# SERVICE BULLETIN SB00.04

**Machines/Models:** SB80

**PURPOSE:** Enhance the performance of the Master Leveling Cylinder

**Figure 1**

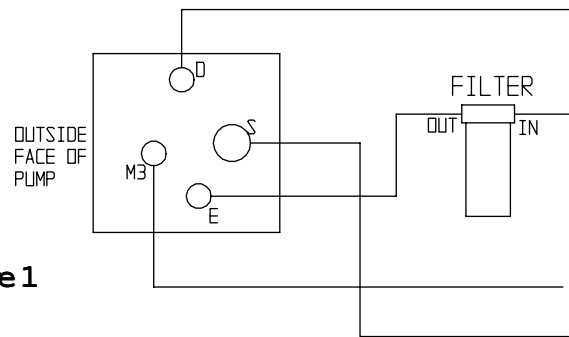
1. Open the right Turret Cover to gain access to the Engine Compartment.
2. Locate the Charge Pump Filter and verify that it is plumbed as follows:
  - a. Inlet of the filter (indicated by an indented arrow) is being supplied from supply line "D" and that the return line is plumbed to return line "E" on charge pump (see Fig 1).
  - b. If the filter head has been incorrectly installed correct the plumbing at the filter head. Torque hose fittings to 25 -30 ft. lbs (35-42 Nm).
  - c. Replace the Charge Pump Filter Element ( P.N.100289-010).

**Figure 2**

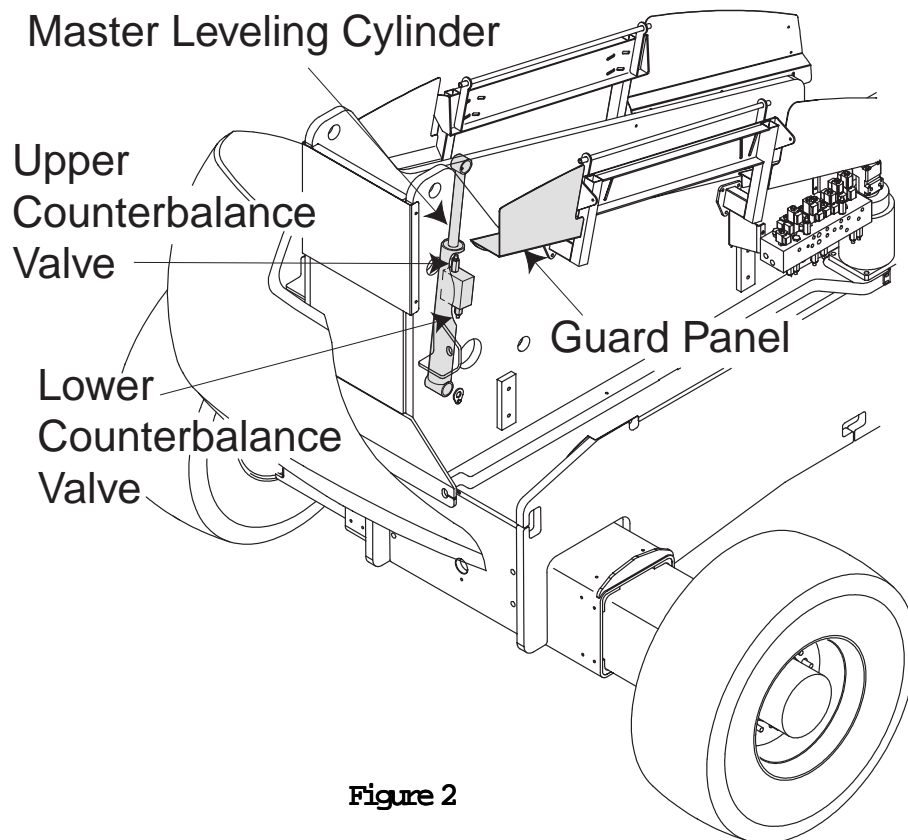
1. From the Chassis Controls elevate the boom to full height.
2. Remove the Guard Panel located above the fuel tank to gain access to the Master Leveling Cylinder (see figure 2).
3. Remove debris or water from the Master Leveling Cylinder Counter Balance Valve counter bore.
4. Remove and discard the upper and lower Counterbalance Valves (see figure 2).
5. Install the replacement Counterbalance Valves (P.N. 102255-005) and torque to 35 - 40 ft. lbs (47-54 Nm).
6. Reinstall the Guard Panel.

**Figure 3**

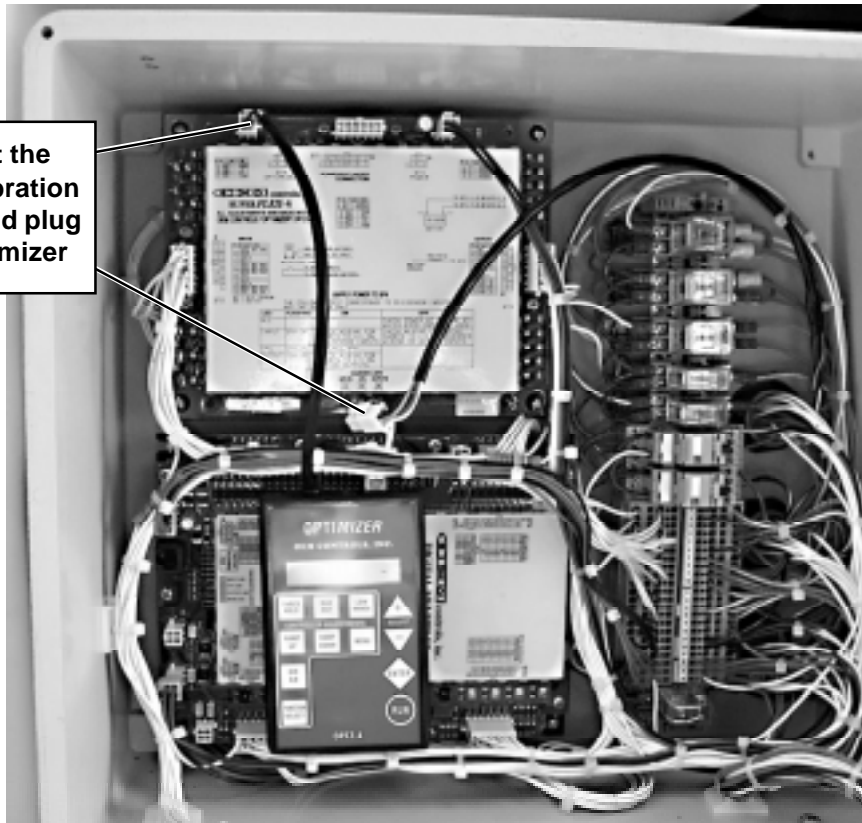
1. Disconnect the upper calibration harness.
2. Plug the Optimizer into the Super Flex (see Figure 3).
3. Operate Lift Down function. The Optimizer will display each setting.
4. If the function is out of adjustment, use the plus and minus adjustment keys on the Optimizer to reset to the proper setting.

Disconnect the  
upper calibration  
harness and plug  
in the Optimizer

MAX	THRESHOLD	RAMP ON	RAMP OFF
Lift Down	95%	40%	0.5	0.2

Boom Lower = 55 to 70 Seconds.
